AS BUILT PLANS

FRANKLIN COUNTY
STATE AIRPORT

PROJECT 03 NO. 2029
SHEET 2 OF 11

ELECTRICAL LAYOUT

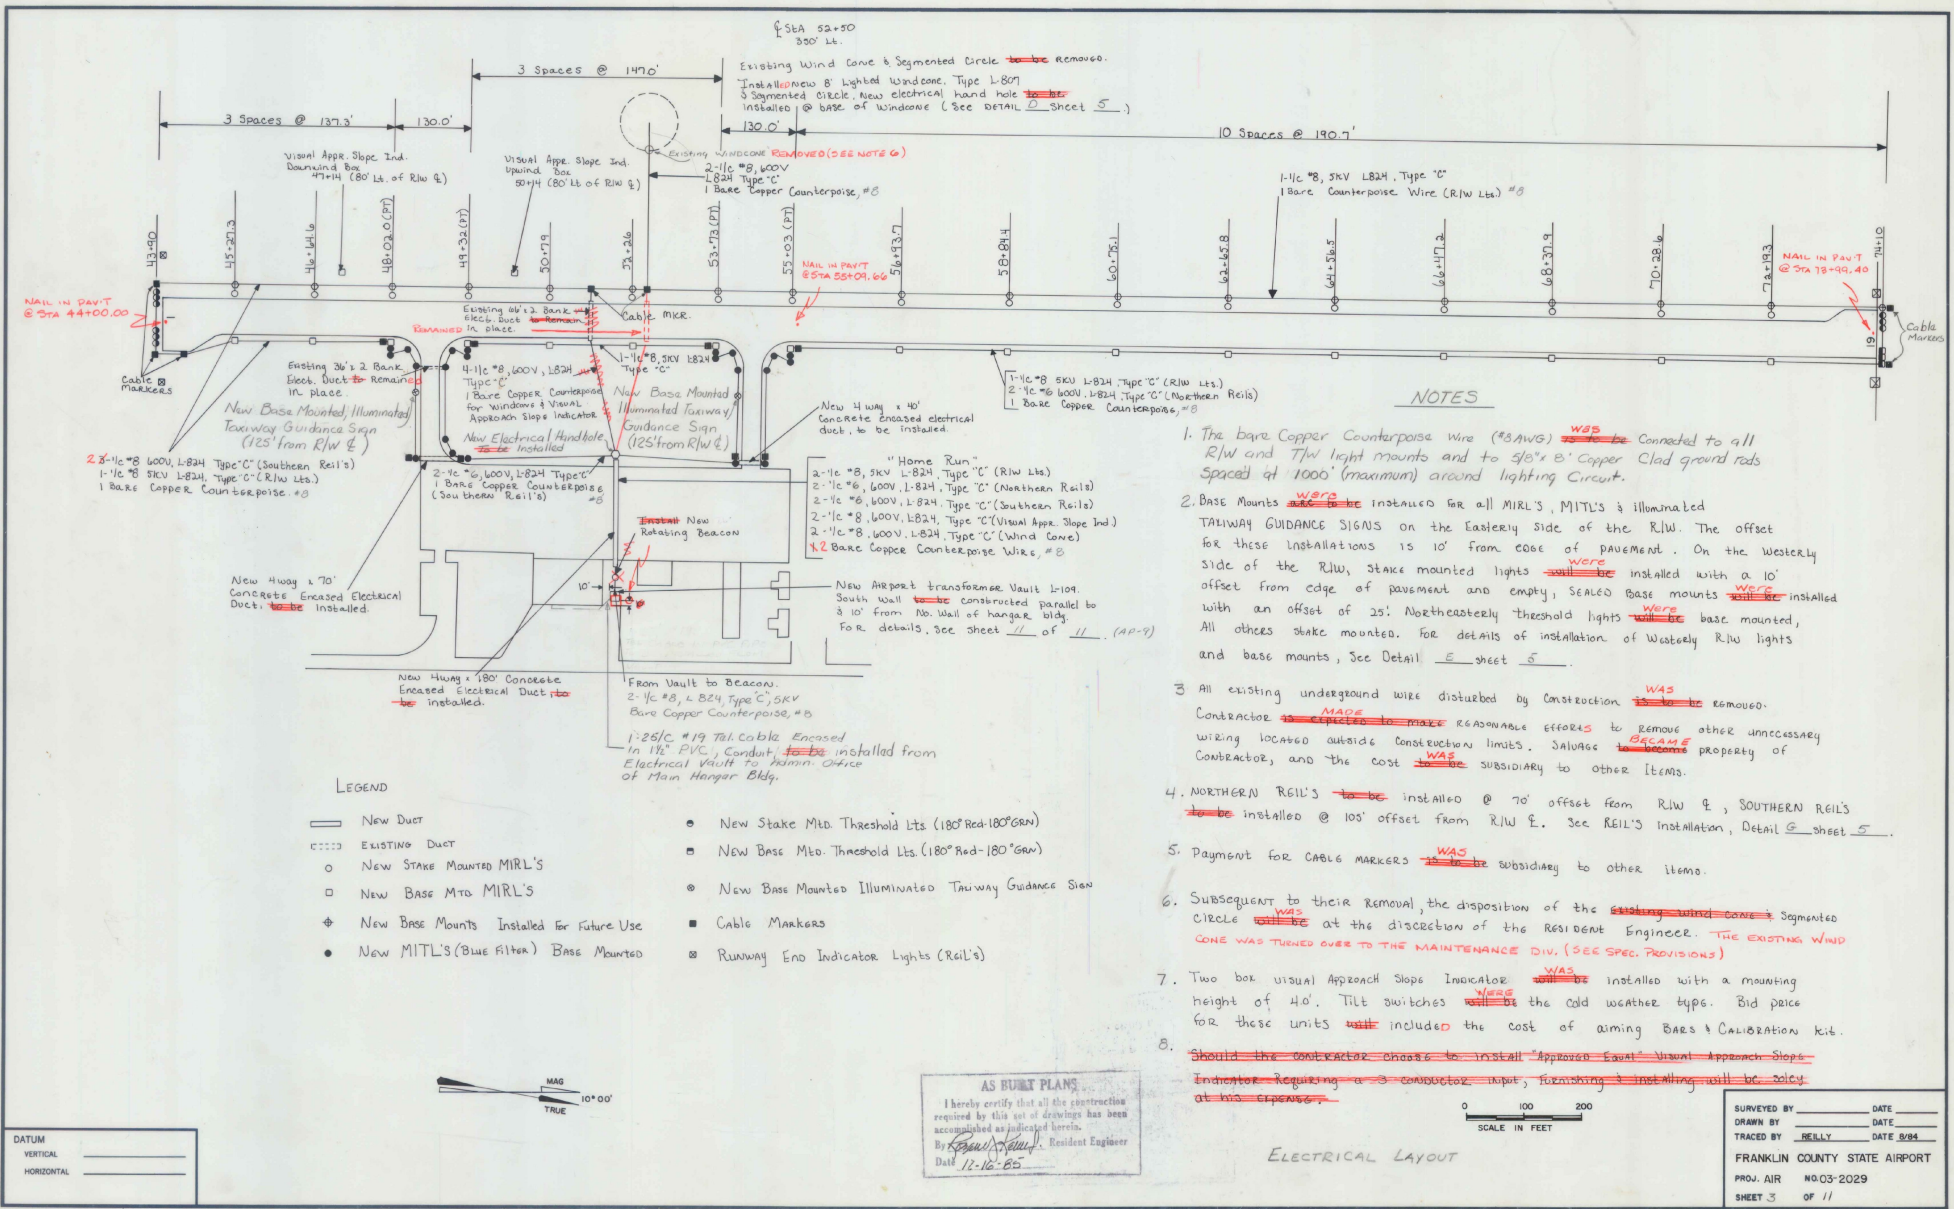
1. The bare Copper Counterpoise wire (#8 AWG) ~~was~~ **was** connected to a 111 R/W and T/W light mounts and to 3/16" x 8" Copper Clad ground rods Spaced at 1000' (maximum) around lighting circuit.

2. Base Mounts ~~are to be~~ **were** installed for all MRL'S, MITL'S & illuminated TAXIWAY GUIDANCE SIGNS on the Eastern Side of the R/W. The offset for these installations is 10' from edge of pavement. On the Western side of the R/W, stake mounted lights ~~will be~~ **were** installed with a 10' offset from edge of pavement and empty, SEALED base mounts ~~will be~~ **were** installed with an offset of 25'. Northeastly threshold lights ~~will be~~ **were** base mounted, All other stake mounted, for details of installation of Western R/W lights and base mounts, See Detail E sheet 5.

3. All existing underground wire disturbed by construction ~~is to be~~ **was** removed. Contractor ~~is to make~~ **was made** reasonable efforts to remove other unnecessary wiring located outside construction limits. Salvage ~~is to be~~ **was** property of Contractor, and the cost ~~is to be~~ **was** subsidiary to other items.

4. NORTHERN RAIL'S ~~to be~~ installed @ 70' offset from R/W & ; SOUTHERN RAIL'S ~~to be~~ installed @ 100' offset from R/W & . See RAIL'S installation, Detail G sheet 5.

5. Payment for CABLE MARKERS ~~is to be~~ **was** subsidiary to other items.
6. Subsequent to their removal, the disposition of the ~~existing wind cone & segmented circle~~ **was** at the discretion of the Resident Engineer. ~~The existing wind cone was turned over to the maintenance div. (see spec. provisions)~~

7. Two box visual Approach Slope Indicator ~~will be~~ **was** installed with a mounting height of 40'. Tilt switches ~~will be~~ **were** the cold weather type. Bid price for these units ~~will be~~ **was** included the cost of wiring Bars & Calibration kit.

8. ~~Should the contractor choose to install "Approved Exam" Visual Approach Slope Indicator. Requiring a #3 conductor input, forming & installing will be solely at his expense.~~

FRANKLIN COUNTY STATE AIRPORT
SCHEMATIC SHEET

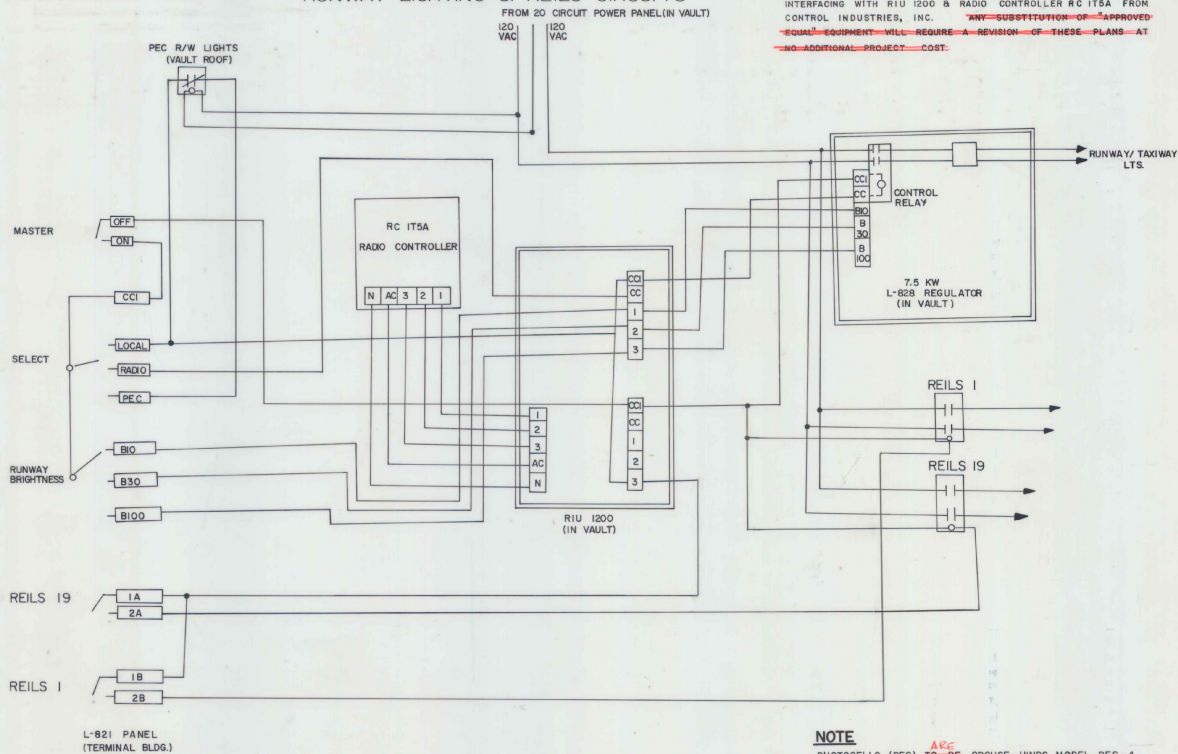
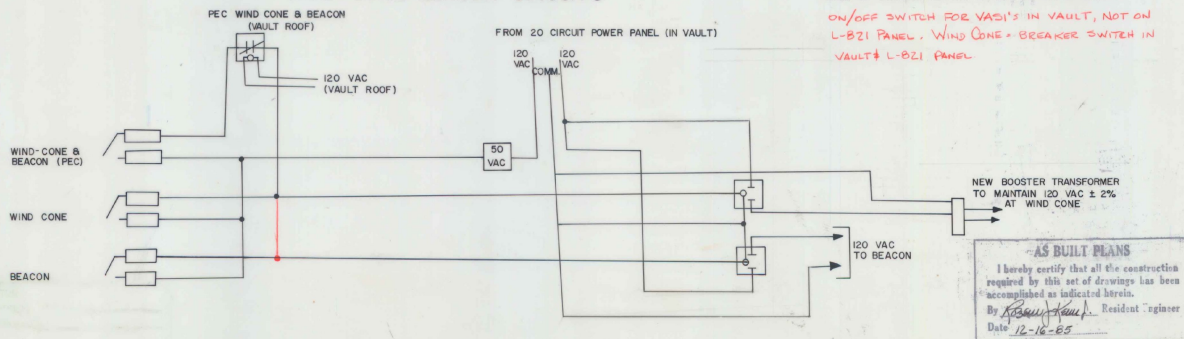
1. ANTENNA FOR RADIO CONTROLLER TO BE MOUNTED ON ROOF OF NEW ELECTRICAL VAULT.
2. RADIO CONTROLLER OPERATION
CIRCUIT #1 (3 CLICKS) MIRLS 10%
CIRCUIT #2 (5 CLICKS) MIRLS 30%
CIRCUIT #3 (7 CLICKS) MIRLS 100%; REILS
RADIO FREQUENCY 122.8 MHz
3. ALL WIRING TO BE IN CONDUIT OR CABLE TRAY.
4. THE CONTACTOR ~~SHOULD BE~~ LABEL EACH CABLE AND/OR CONDUCTOR AT EVERY TERMINAL POINT OR JUNCTION.
5. INTERNAL WIRING FOR 48 VDC CONTROL VOLTAGE SUPPLY AT THE POWER REGULATOR MAY VARY.
6. THE L-821 PANEL ~~SHOULD BE~~ LOCATED IN THE ADMIN. OFFICE OF THE MAIN HANGAR .48 VDC CONTROL VOLTAGE FROM VAULT ~~SHOULD BE~~ VIA 25/0 #19 TEL. CABLE ENCASED IN 1 1/2" P.V.C. CONDUIT.

DETAIL "B" VAULT LAYOUT

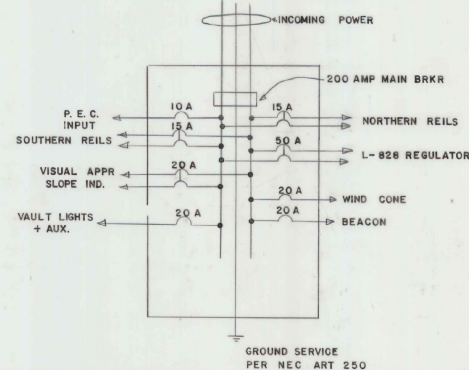
- EQUIPMENT SCHEDULE
- 1 NEW 20 CIRCUIT POWER PANELBOARD FED. SPEC W-P-115A & W-C-375B.
 - 2 NEW 7.5 KW L-828 REGULATOR ~~SHOULD BE~~ HEVI-DUTY ELECTRIC, CAT. NO. 7L82800A-(3) OR APPROVED EQUAL.
 - 3 RADIO INTERFACING UNIT ~~SHOULD BE~~ RIU-1200 FROM CONTROL INDUSTRIES, INC. OR APPROVED EQUAL.
 - 4 RADIO CONTROLLER TO MEET STANDARDS SET FORTH IN AC 150/3345-49.
 - 5 MOUNT BOOSTER TRANSFORMER, RELAYS & CONTACTORS IN NEMA ENCLOSURES ON EAST WALL 4' A.F.F. BOOSTER TRANSFORMER FOR WIND CONE 120 VAC ~~SHOULD BE~~ CROUSE-HINDS CAT. NO. 44513 OR EQUAL.
 - 6 CONTROL STATION FOR VISUAL APPROACH SLOPE INDICATOR ~~SHOULD BE~~ LOCATED ON EAST WALL OF VAULT. (SEE DETAIL.)

FRANKLIN COUNTY
 STATE AIRPORT
 DISPOSITION OF OBSTRUCTIONS

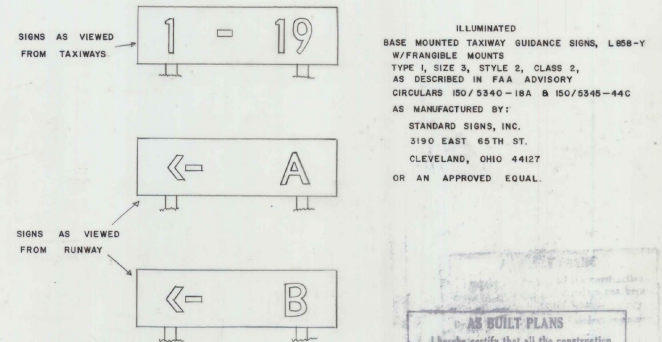
NOTE: ITEM 20110, CLEARING & GRUBBING PLUS INDIV.
 TREES & STUMPS DELETED FROM CONTRACT
 WORK ACCOMPLISHED BY DISTRICT FORCES.
